**ISSUE:** Certificate of Appropriateness for alterations

**APPLICANT:** Taco Bell of America represented by Joanie Godsey, Architect

**LOCATION:** Old and Historic Alexandria District  
417 King Street

**BAR#2025-00021 - OHAD**  
**417 King Street**

WALK-UP  
 WINDOW

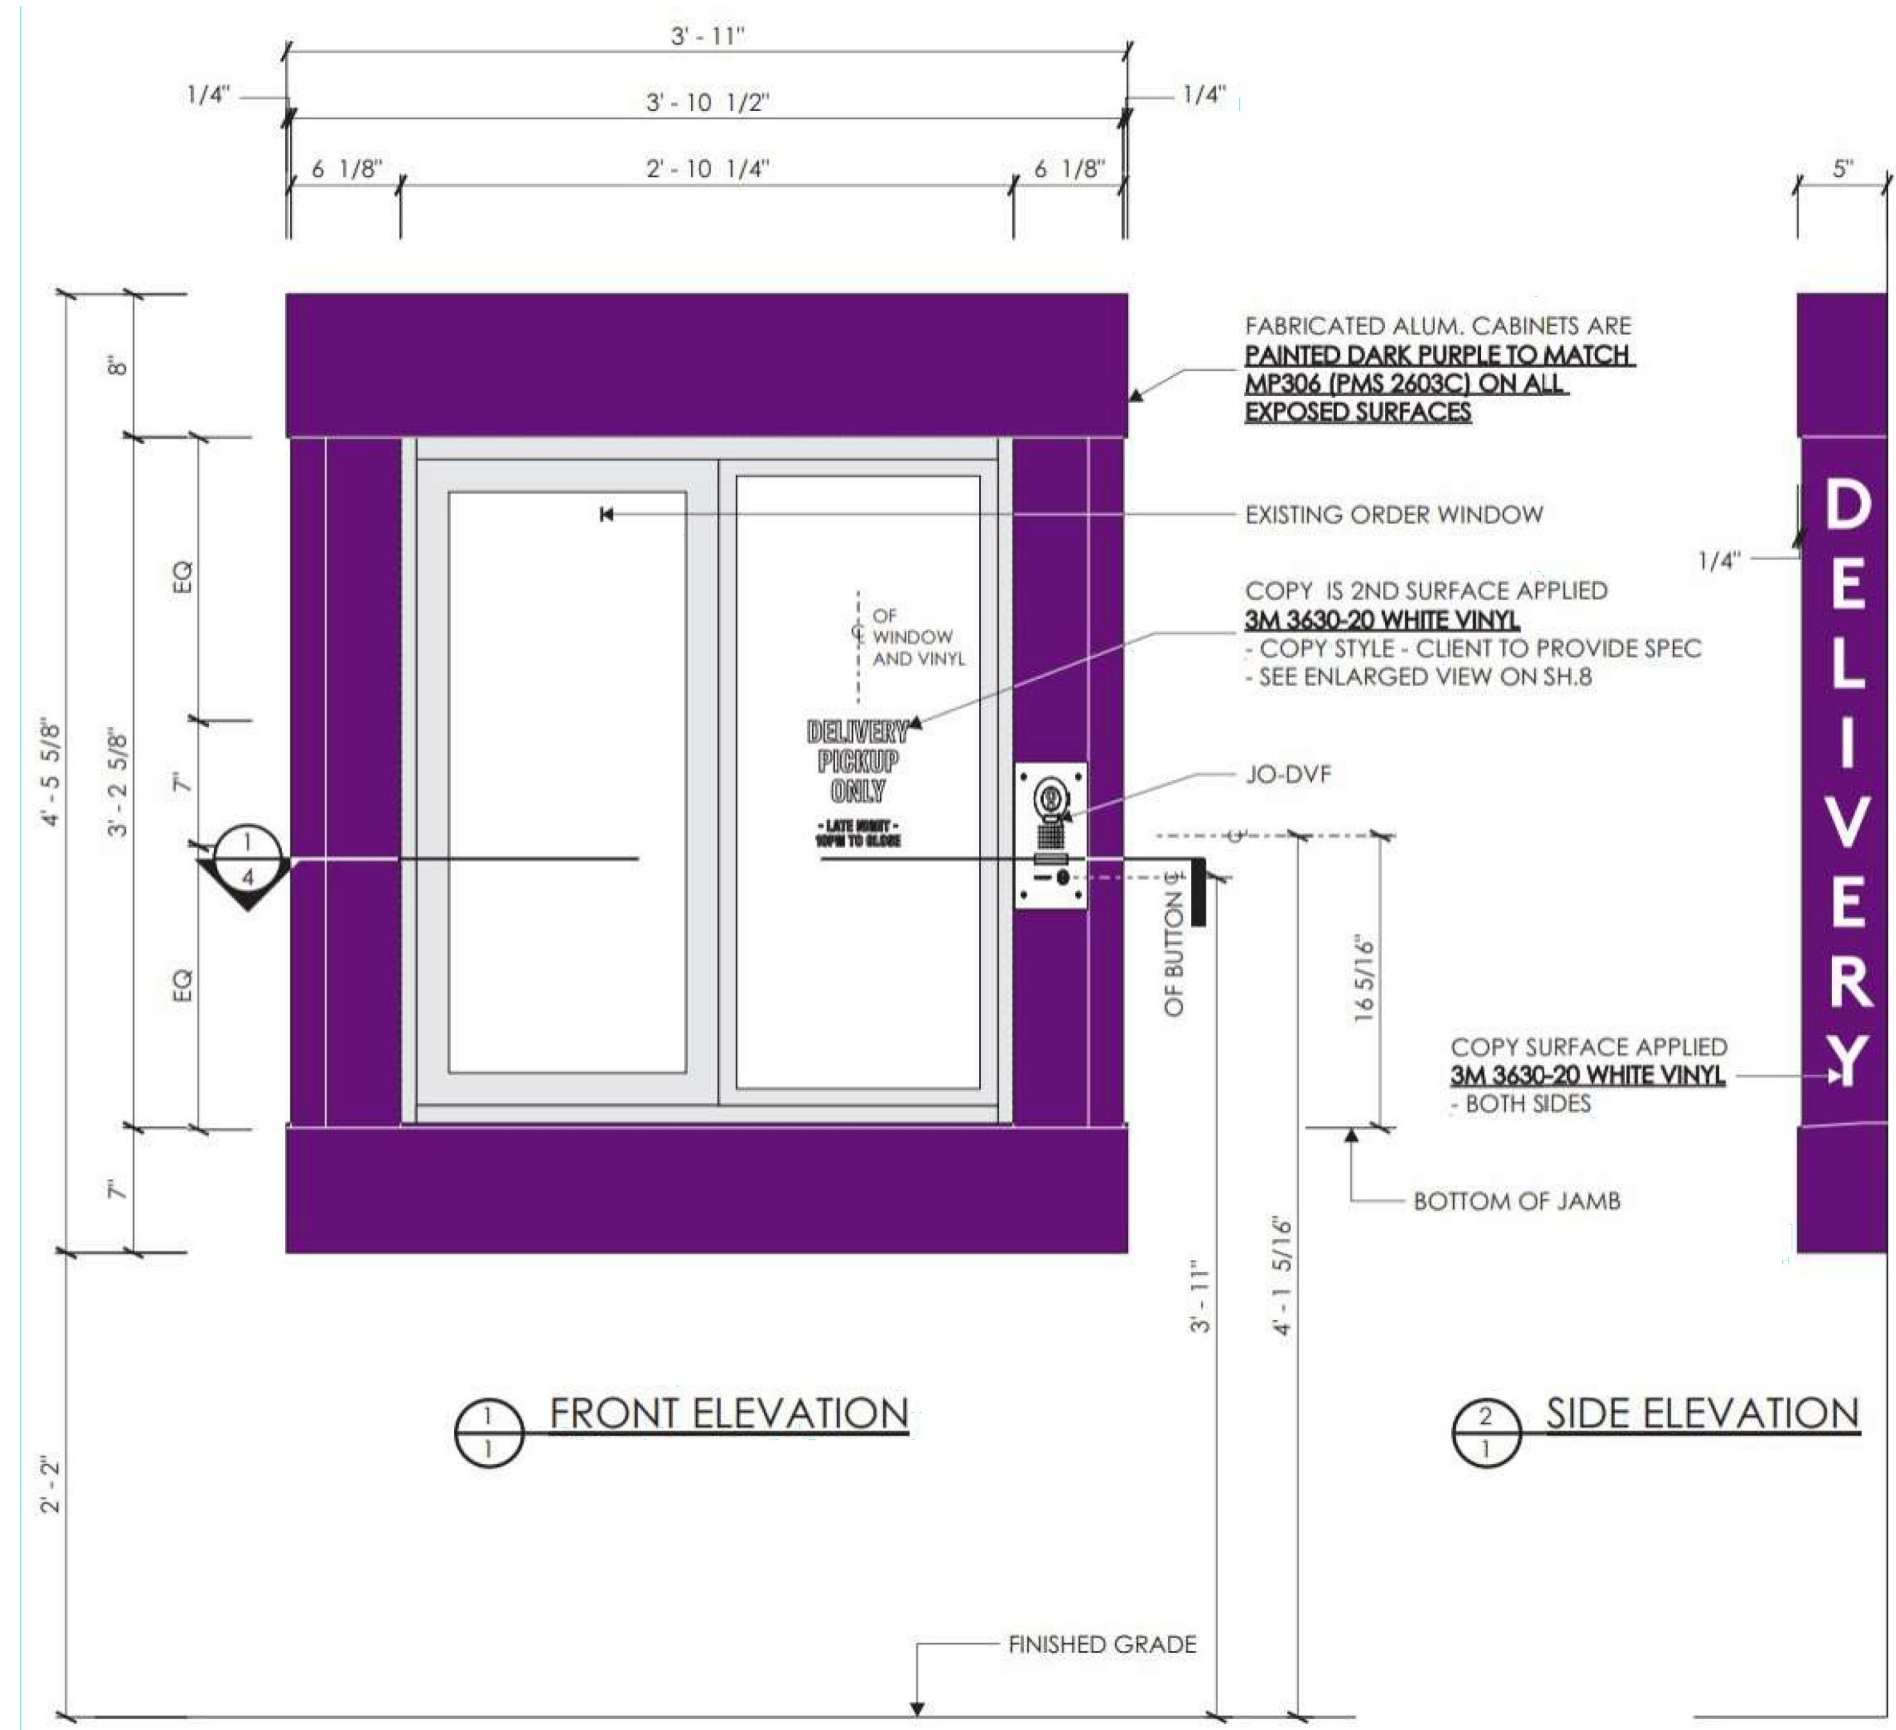
The applicant proposes to paint the fabricated aluminum cabinet surrounding the pickup window a vibrant shade of purple. The selected shade is too intense and isn't harmonious with the existing signage. For reference, below is a photo of a recently installed pickup window at the upcoming 14<sup>th</sup> and U St., NW Taco Bell Cantina in Washington, DC. Staff recommend that the color of the proposed pickup window matches the existing signage and storefront. The applicant should work with staff to update the colors before applying for a building permit.

Staff recommends approval of the Certificate of Appropriateness for alterations with the condition that applicant work with staff to update the colors of the pickup window before applying for a building permit.
